JV10-NL Block Diagram

Project code: 91.4HX01.001
PCB P/N : 48.4HX01.0SB
REVISION : SB

Title: **Modify History**

Date: Sunday, January 31, 2010 Sheet 42 of 42

Sheet 31 of 42

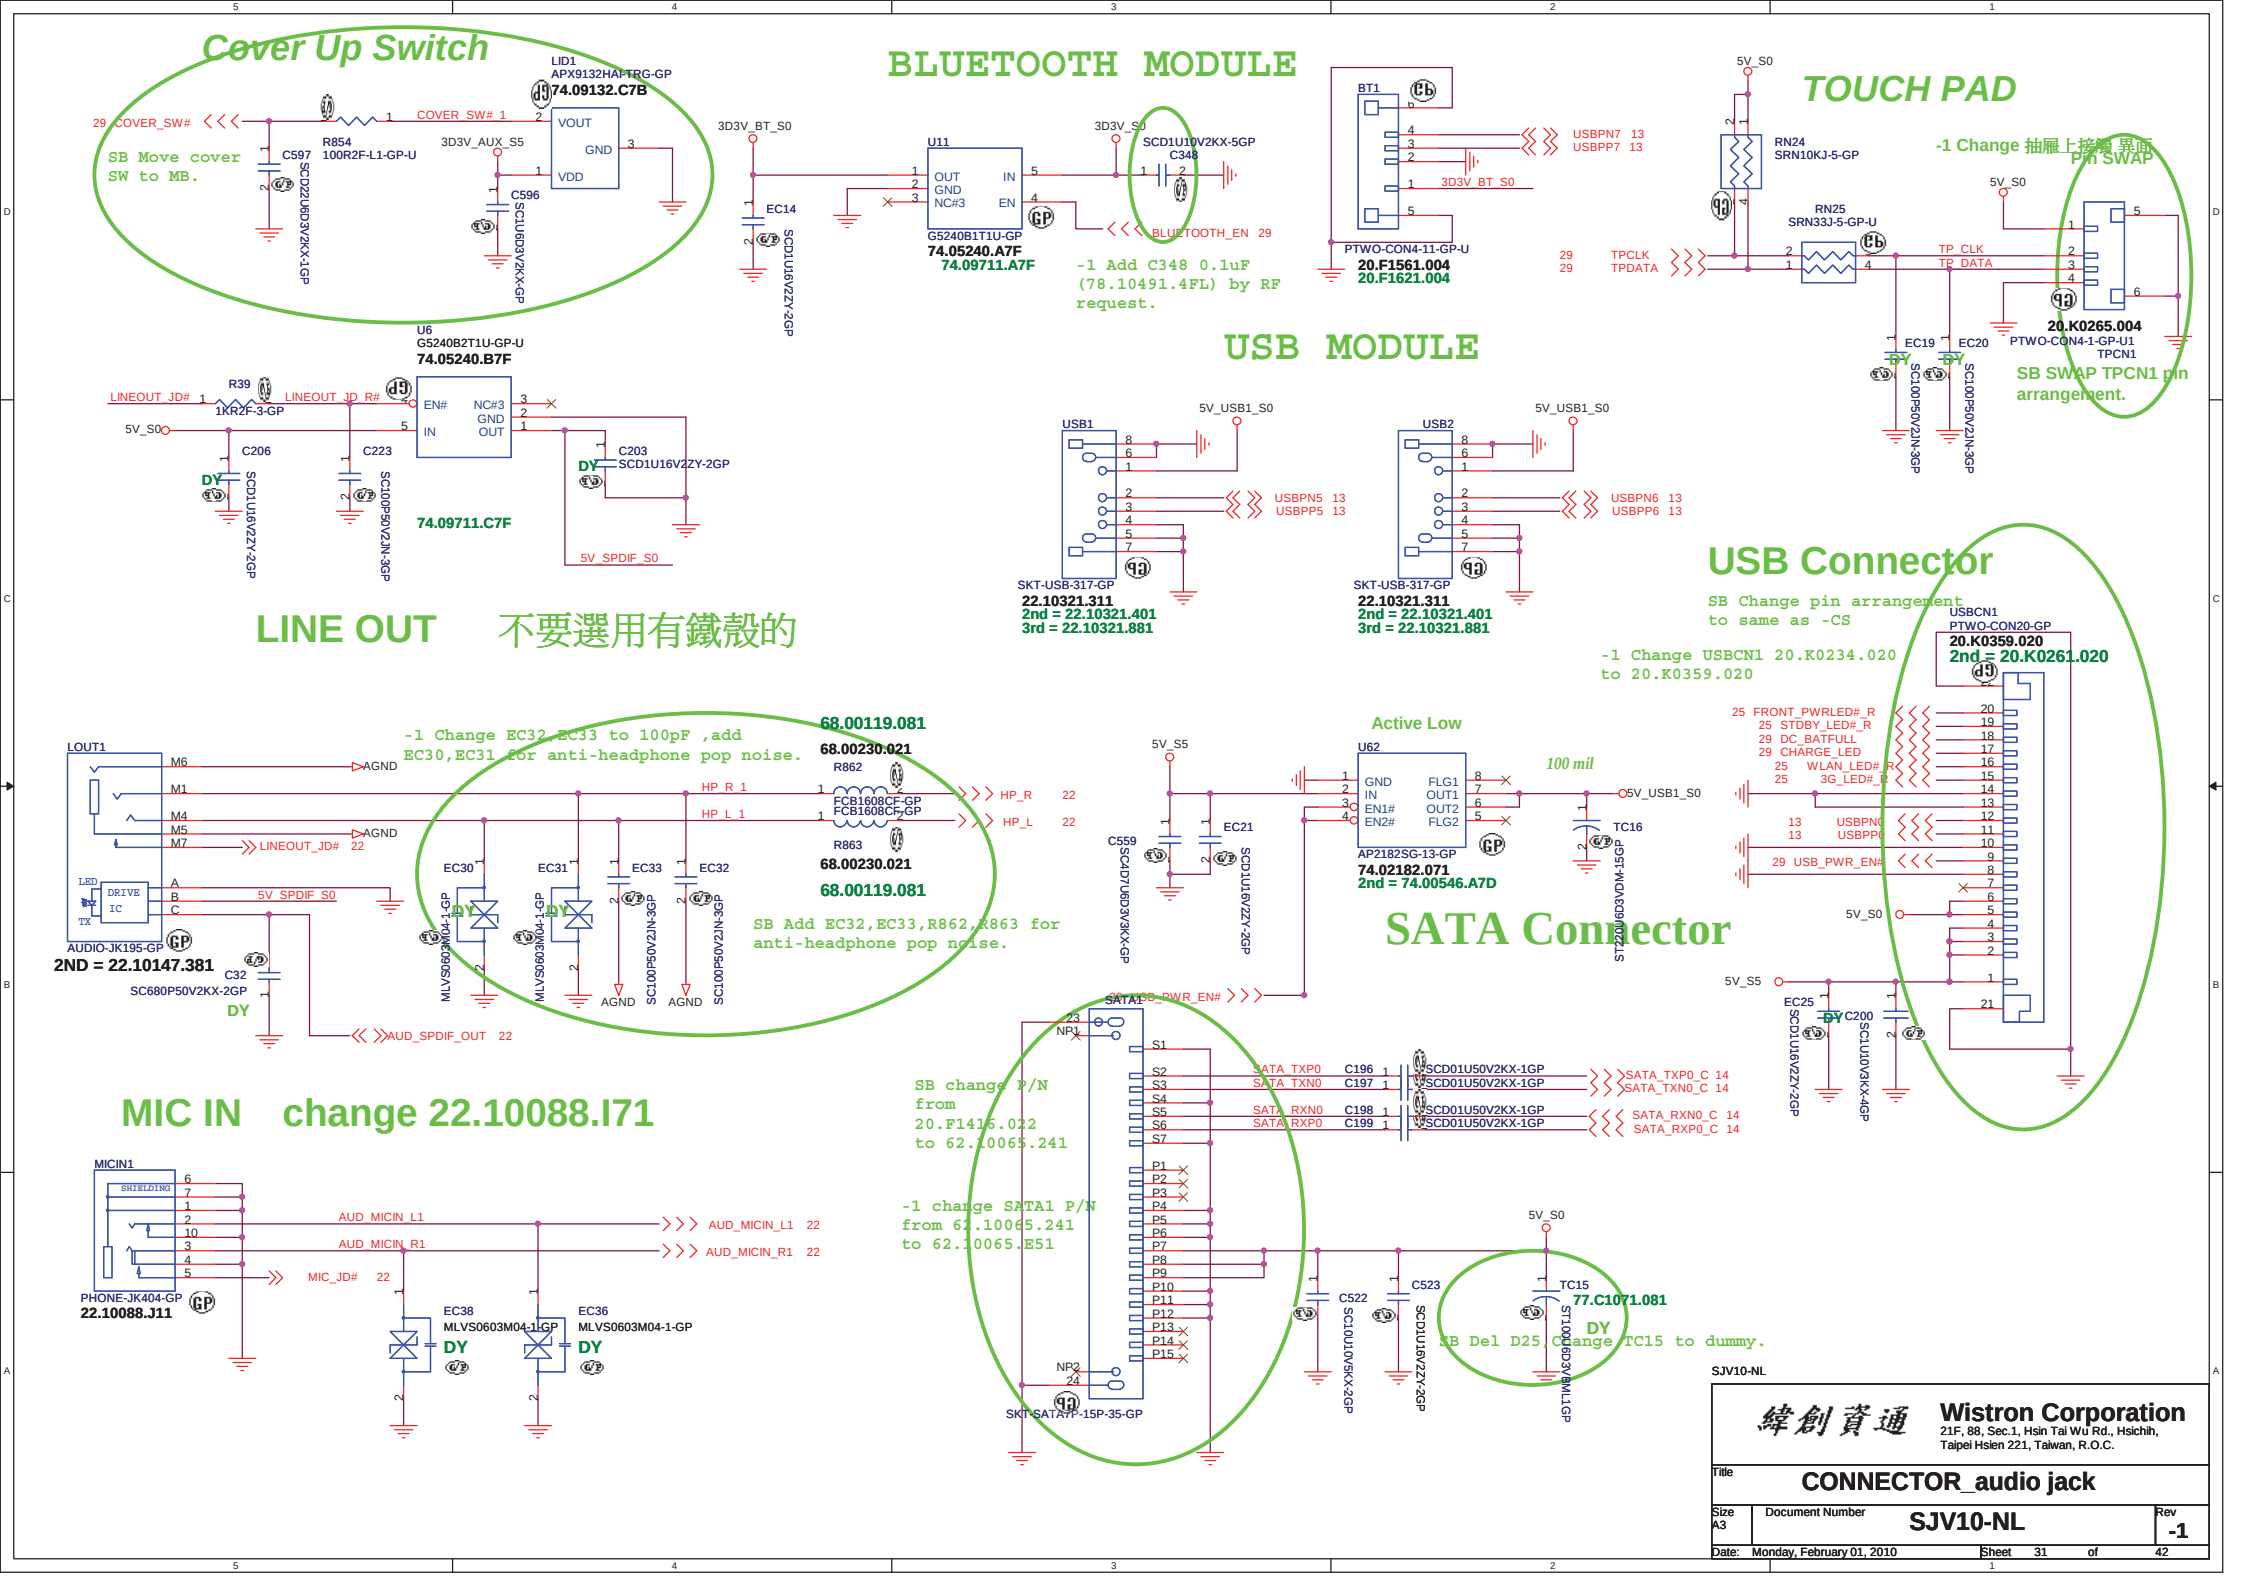
74.05240.A7F
74.09711.A7F
OUT
IN
GND
NC#3
EN
3D3V_S0
SCD1U10V2KX-5GP
C348
BLUETOOTH_EN 29
-1 Add C348 0.1uF (78.10491.4FL) by RF request.
BT1
PTWO-CON4-11-GP-U
20.F1561.004

20.F1621.004
USBPN7 13
USBPP7 13
3D3V_BT_S0
TOUCH PAD
5V_S0
RN24
SRN10KJ-5-GP
RN25
SRN33J-5-GP-U
TP_CLK
TP_DATA
29 TPCLK
29 TPDATA
-1 Change 抽屜上接觸 界面 Pin SWAP
20.K0265.004
PTWO-CON4-1-GP-U1
TPCN1
EC19
EC20
SC100P50V2JN-3GP
SB SWAP TPCN1 pin arrangement.
U6
G5240B2T1U-GP

22.10321.311
2nd = 22.10321.401
3rd = 22.10321.881
USB Connector
SB Change pin arrangement to same as -CS
-1 Change USBCN1 20.K0234.020 to 20.K0359.020
USBCN1
PTWO-CON20-GP

68.00119.081
68.00230.021
R862
R863
FCB1608CF-GP
HP_R_1
HP_L_1
HP_R 22
HP_L 22
SB Add EC32,EC33,R862,R863 for anti-headphone pop noise.
Active Low
U62
AP2182SG-13-GP

74.02182.071
2nd = 74.00546.A7D
100 mil
5V_S5
EC21
SCD1U16V2ZY-2GP
SC4D7U6D3V3KX-GP
TC16
ST220U6D3VDM-15GP
5V_USB1_S0
SATA Connector
SATA1
SKT-SATA7P-15P-35-GP
SB change P/N from 20.F1416.022 to 62.10065.241
-1 change SATA1 P/N from 62.10065.241 to 62.10065.E51
SATA_TXP0
SATA_TXN0
SATA_RXN0
SATA_RXP0
C196
C197
C198
C199
SCD01U50V2KX-1GP
SATA_TXP0_C 14
SATA_TXN0_C 14
SATA_RXN0_C 14
SATA_RXP0_C 14
C522
C523
SC10U10V5KX-2GP
SCD1U16V2ZY-2GP
TC15

77.C1071.081
DY
SB Del D25,Change TC15 to dummy.
MIC IN change 22.10088.I71
MICIN1
PHONE-JK404-GP
22.10088.J11
AUD_MICIN_L1
AUD_MICIN_R1
MIC_JD# 22
EC38
EC36
MLVS0603M04-1-GP
SJV10-NL
緯創資通
Wistron Corporation
21F, 88, Sec.1, Hsin Tai Wu Rd., Hsichih, Taipei Hsien 221, Taiwan, R.O.C.
Title
CONNECTOR_audio jack
Size A3
Document Number
SJV10-NL
Rev -1
Date: Monday, February 01, 2010

Sheet 38 of 42

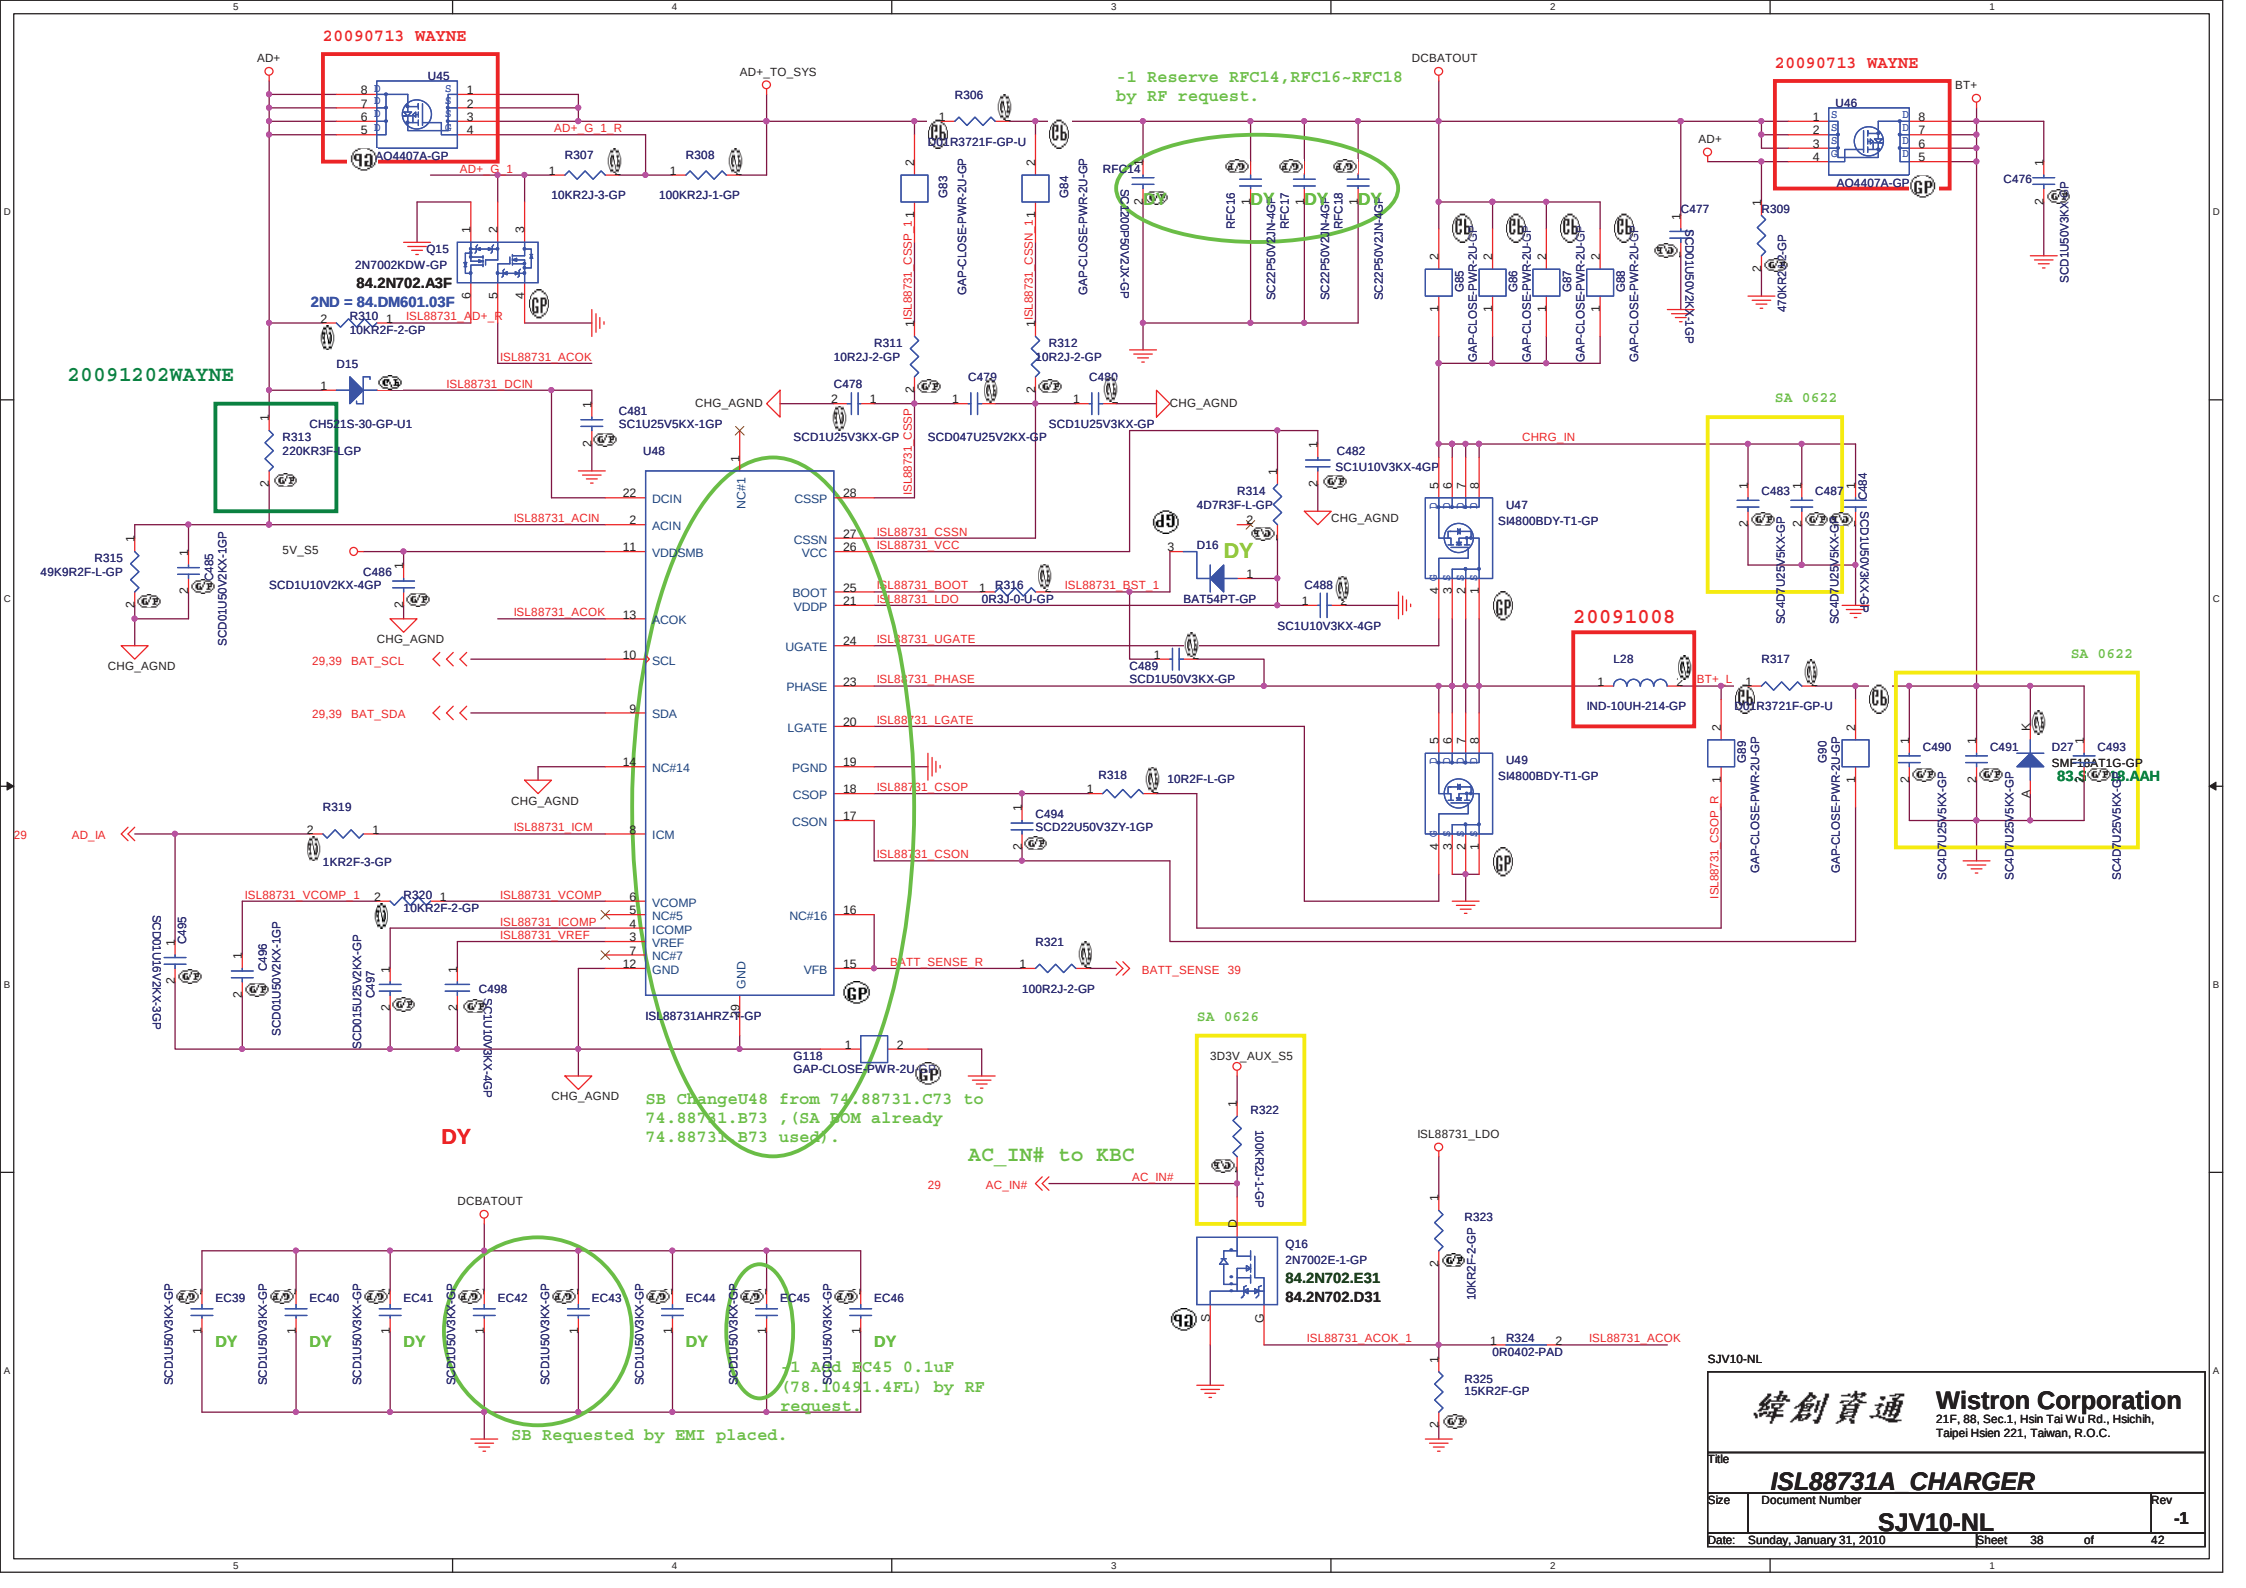
84.2N702.E31
84.2N702.D31
R323
10KR2F-2-GP
R324
0R0402-PAD
R325
15KR2F-GP
ISL88731_ACOK_1
SB ChangeU48 from 74.88731.C73 to 74.88731.B73 ,(SA ROM already 74.88731.B73 used).
DY
EC39
EC40
EC41
EC42
EC43
EC44
EC45
EC46
SCD1U50V3KX-GP
Add EC45 0.1uF (78.10491.4FL) by RF request.
SB Requested by EMI placed.
SJV10-NL
Wistron Corporation
21F, 88, Sec.1, Hsin Tai Wu Rd., Hsichih, Taipei Hsien 221, Taiwan, R.O.C.
Title
ISL88731A CHARGER
Size
Document Number
SJV10-NL
Rev
-1
Date: Sunday, January 31, 2010

緯創資通 Wistron Corporation 21F, 88, Sec.1, Hsin Tai Wu Rd., Hsichih, Taipei Hsien 221, Taiwan, R.O.C.		
Title: EMI/Spring/Boss		
Size	Document Number: SJV10-NL	Rev: -1
Date: Wednesday, January 27, 2010	Sheet 40 of 42

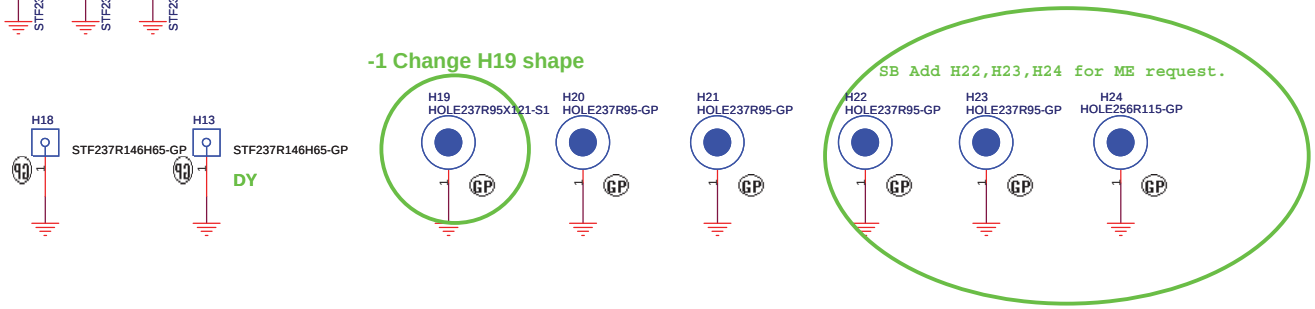
-1 Add SPR1 for RTC battery.

-1 Change H19 shape

SB Add H22,H23,H24 for ME request.
